**ABRACON, LLC
ENGINEERING/PROCESS CHANGE NOTIFICATION FORM**

SCD/DRAWING AFFECTED:
AFAC110020-S698

ECN # 3400

AFAC110020-S698

VSWR

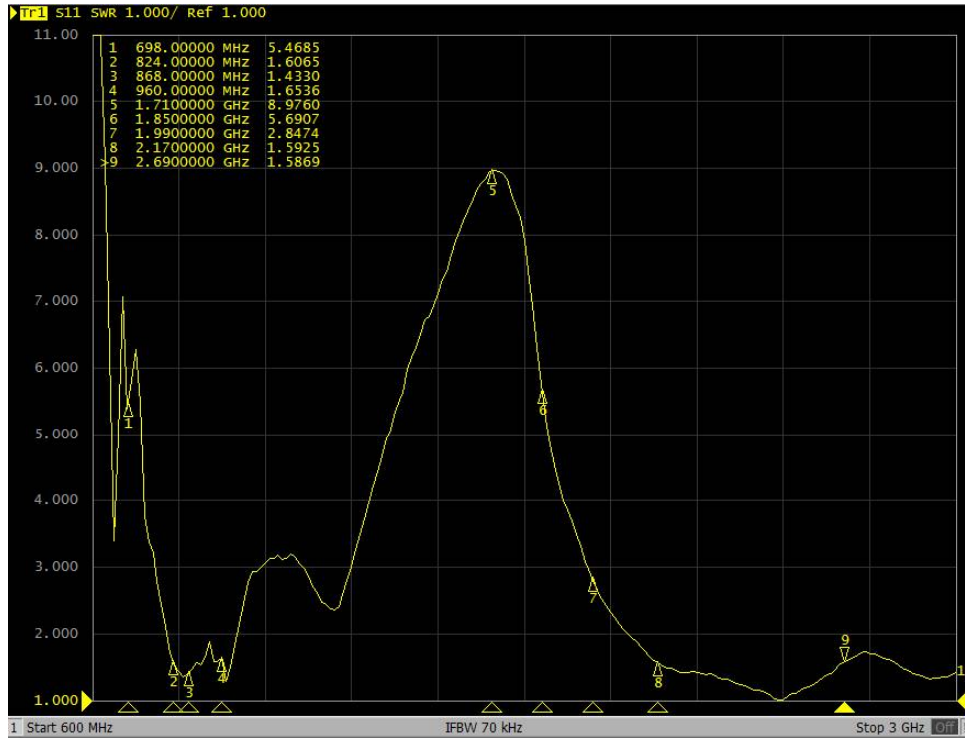
Rev. A
Updated SWR, Radiation Pattern, Efficiency and Gain
